## **PLANNING AND ZONING COMMISSION REGULAR MEETING AGENDA**

Wednesday, August 8, 2018

Consideration, discussion, and possible action on a Preliminary Plan for Stonewater North, three hundred fifty seven (357) single family lots on 69.83 acres, more or less, located near FM 973 N and Johnson Road, Manor, Texas. Applicant: Kitchen Table Civil Solutions. Owner: Continental Homes of Texas

The first submittal of the Stonewater North preliminary 1-3 (*Preliminary Plan*) submitted by Kitchen Table Civil Solutions and received on June 13, 2018, have been reviewed for compliance with the City of Manor Subdivision Ordinance 263B.

COVER SHEET

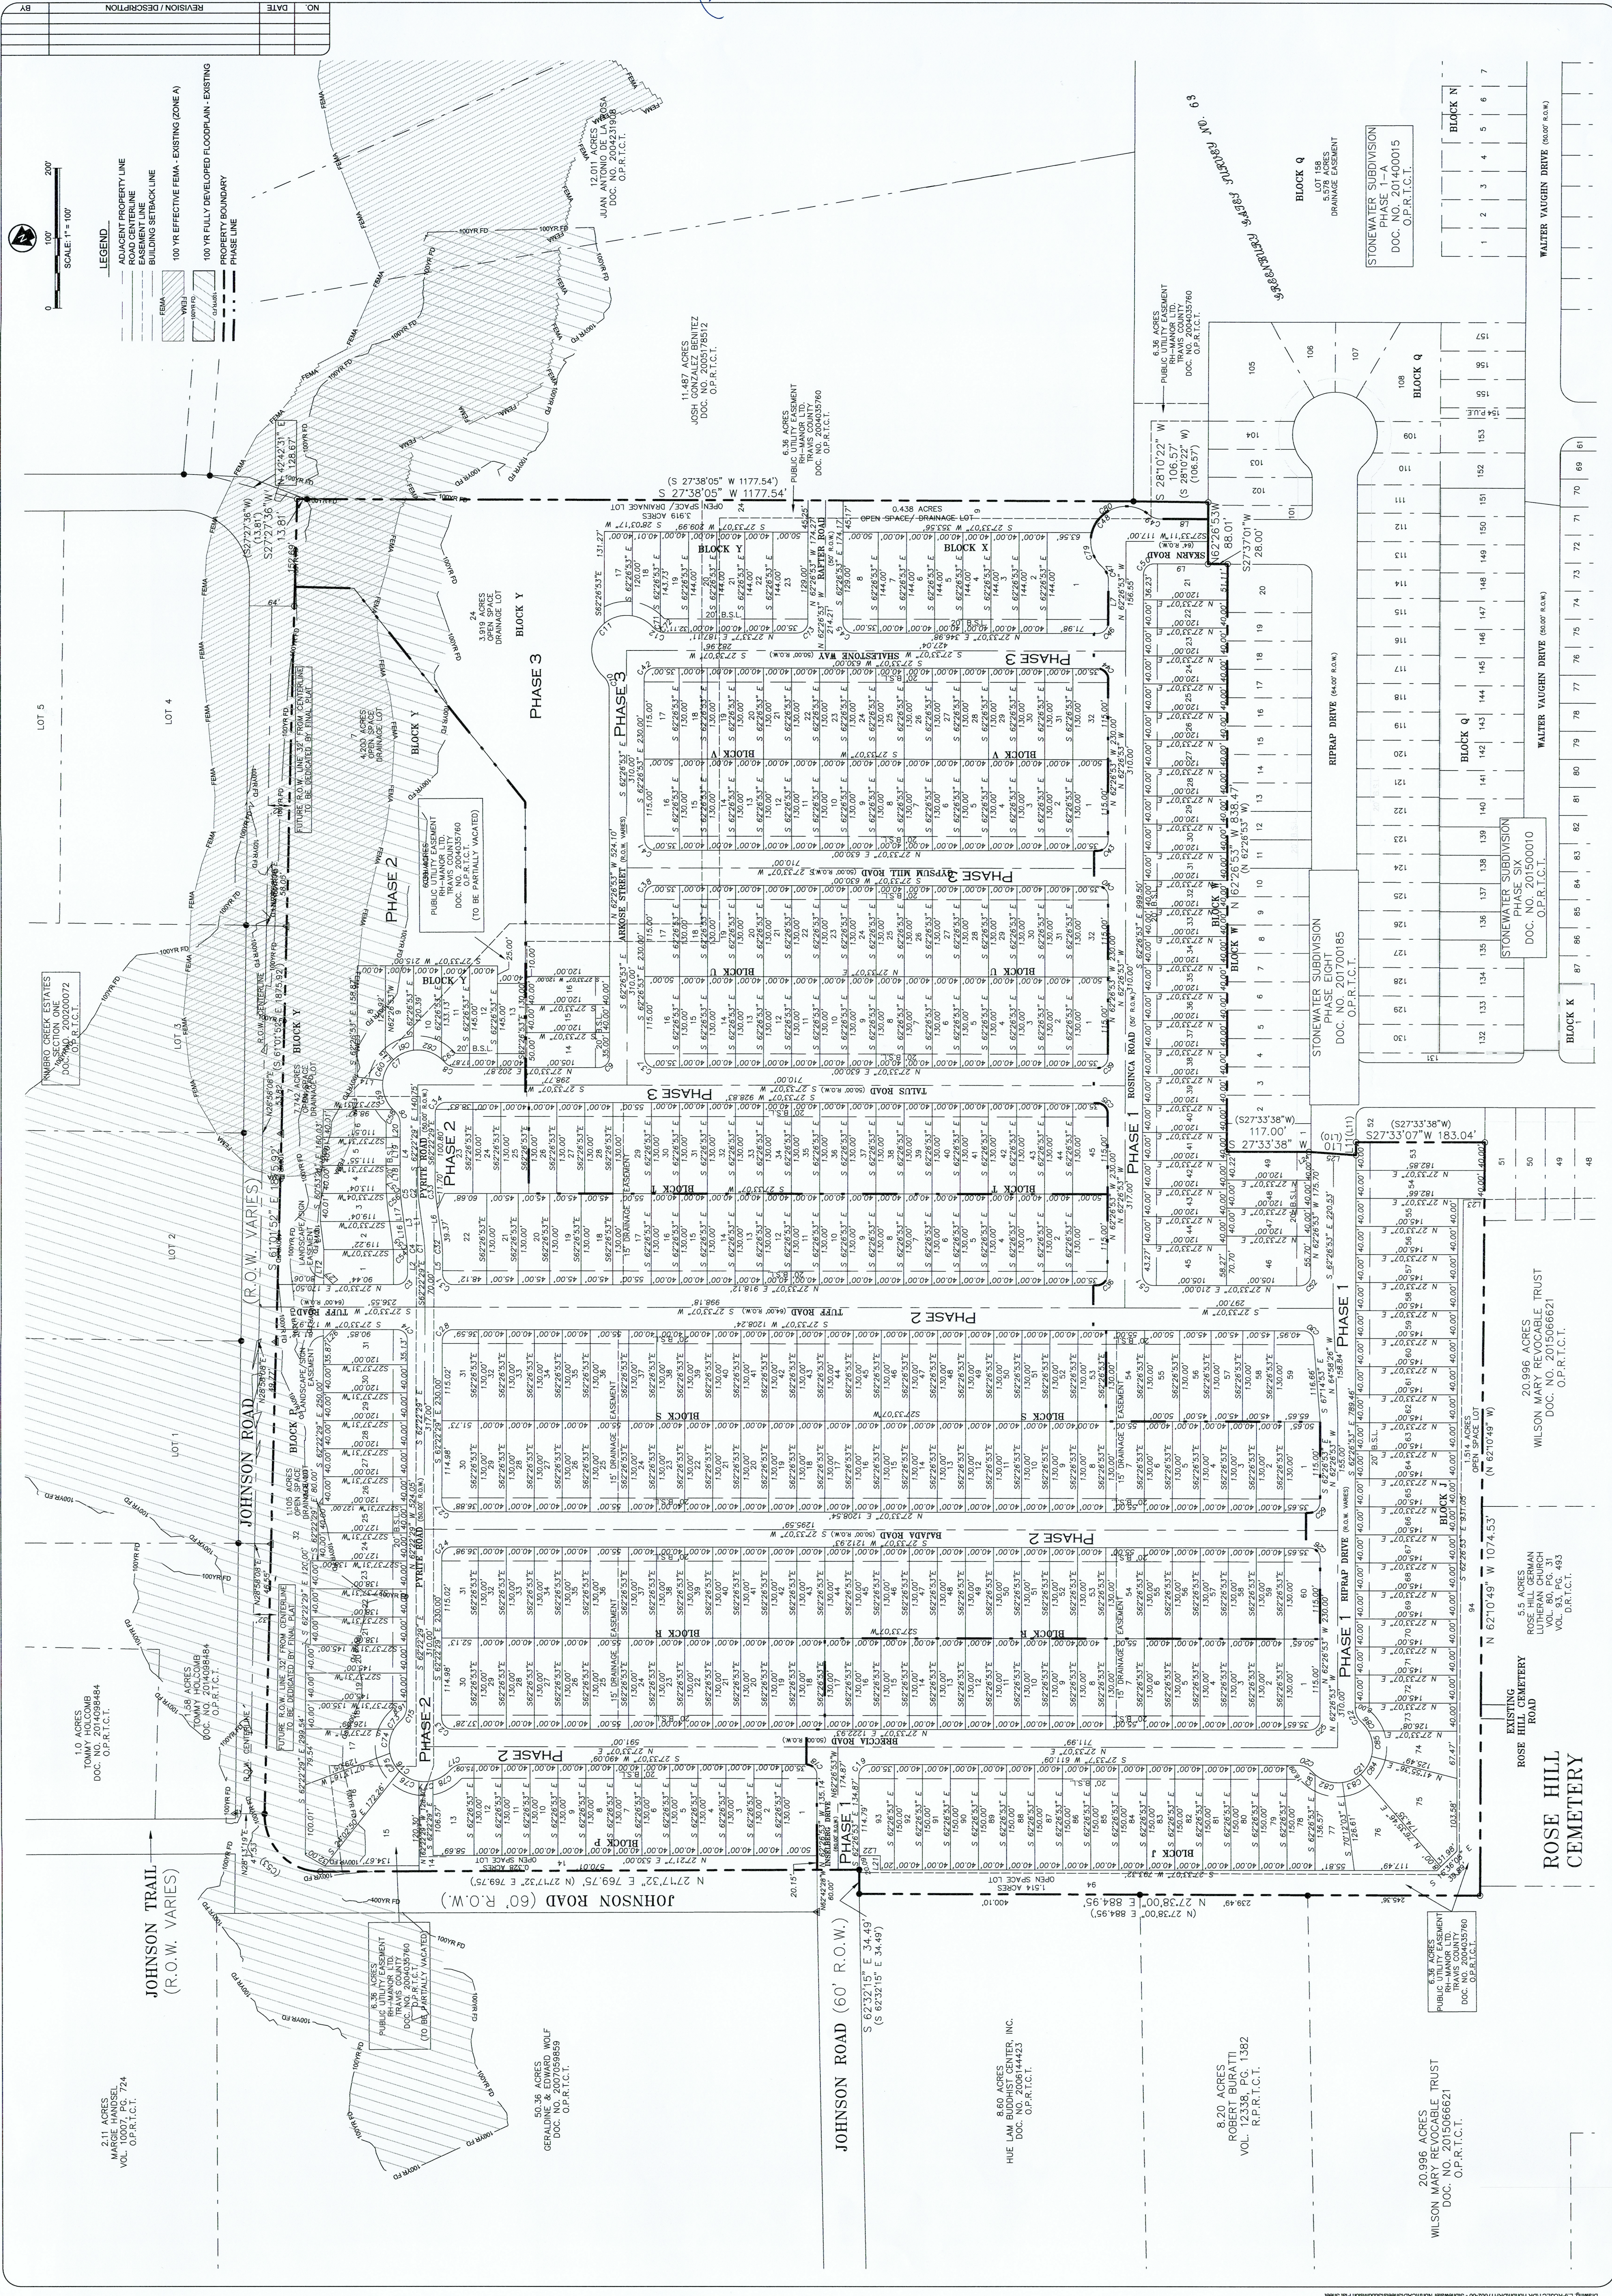
1. The TCESD No. 12 signature block should be removed from the Cover Sheet.
2. Identify and provide mailing labels for property owner's within three hundred (300) feet of the subdivision boundary, together with the respective plat or deed references as determined by the most recent tax roles.

1. The TCESD No. 12 signature block should be removed from the Cover Sheet.

**Response: The TCESD No. 12 signature block has been removed as requested.**
